Resource Planning Advisory Group feedback report

Meeting details

- Tuesday, August 25, 2026, 1:00 p.m. - 3:00 p.m.
- Virtual webinar hosted by PSE and facilitated by Maul Foster & Alongi
- Links to:
 - [Presentation](#)
 - [Agenda](#)
 - [Meeting recording](#)

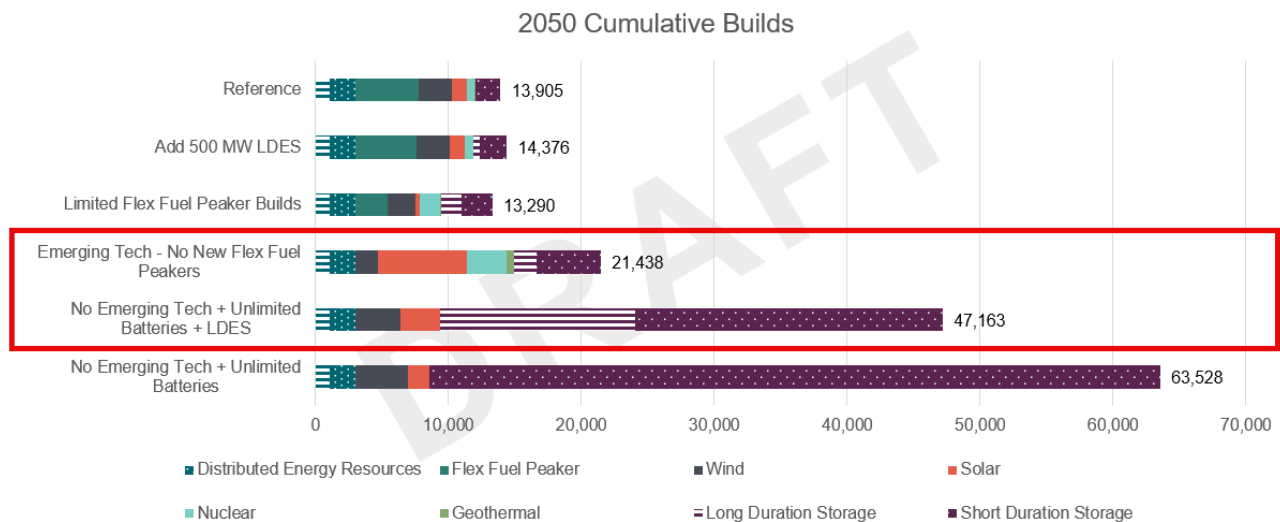
- PSE should explain whether the ELCC tranches are calculated independently by duration or whether deployment of one duration reduces the capacity credit available to other lithium-ion configurations.

The ELCC tranches for short and mid duration batteries saturate together. So, if tranche 1 is saturated with short duration storage, then both short and mid duration storage will move to tranche 2 for the next development of storage. Long-duration storage saturates independently.

Solar is grouped together for saturation, and wind is grouped into the zones Northwest and Rockies.

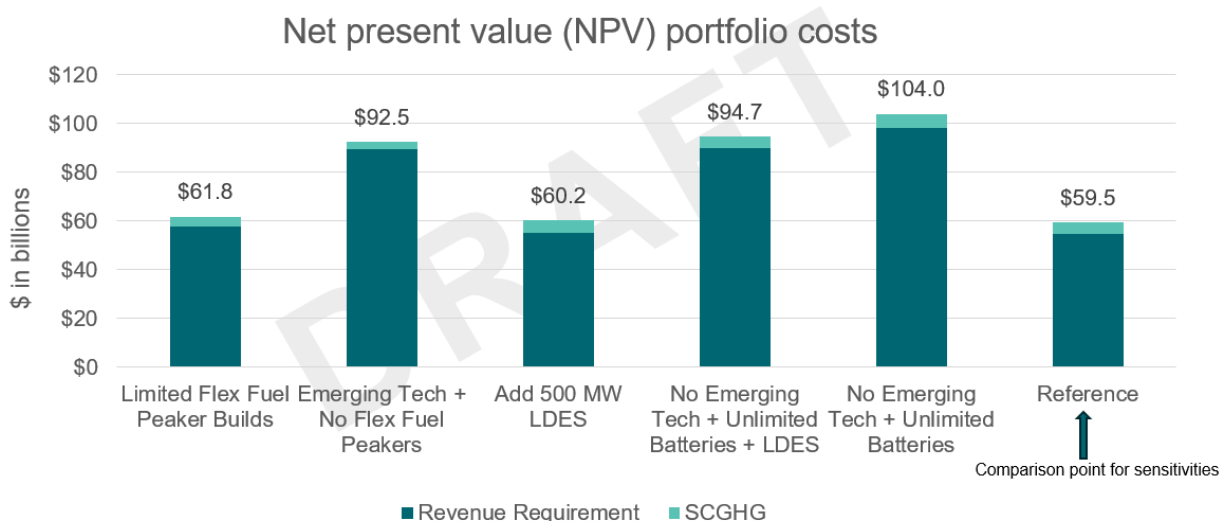
- PSE should run a sensitivity that
 - Excludes new flex-fuel peakers;
 - Allows 4-, 6-, and 8-hour lithium-ion storage, renewable-storage hybrids, demand flexibility, and transmission solutions to compete using resource-specific costs and accreditation;
 - Progressively replaces the capacity contribution of existing gas before 2045 rather than creating an abrupt compliance-year cliff; and
 - Reports resource additions, nameplate capacity, accredited capacity, costs, and emissions separately for approximately the first and second decades of the planning horizon.

PSE evaluated two versions of this sensitivity (with and without emerging technology) and presented the results during the August 2026 RPAG meeting. The version with no emerging technology included short duration storage (2-6 hours) and the version with emerging technology

included short duration along with the mid duration storage (8-24 hours) and long duration storage (100 hours). The “Emerging Tech – No Flex Fuel peakers” sensitivity includes all battery options along with hybrids. The figure below is from that presentation and illustrates the builds for both sensitivity variations. Please note PSE models progressively replacing existing gas resources beginning in 2038 in all scenarios and sensitivities to avoid the “compliance-year cliff”.

NPV for each sensitivity is included in the figure below. Additional details, such as incremental builds in years other than 2050, will be included in the filed ISP and related work papers.
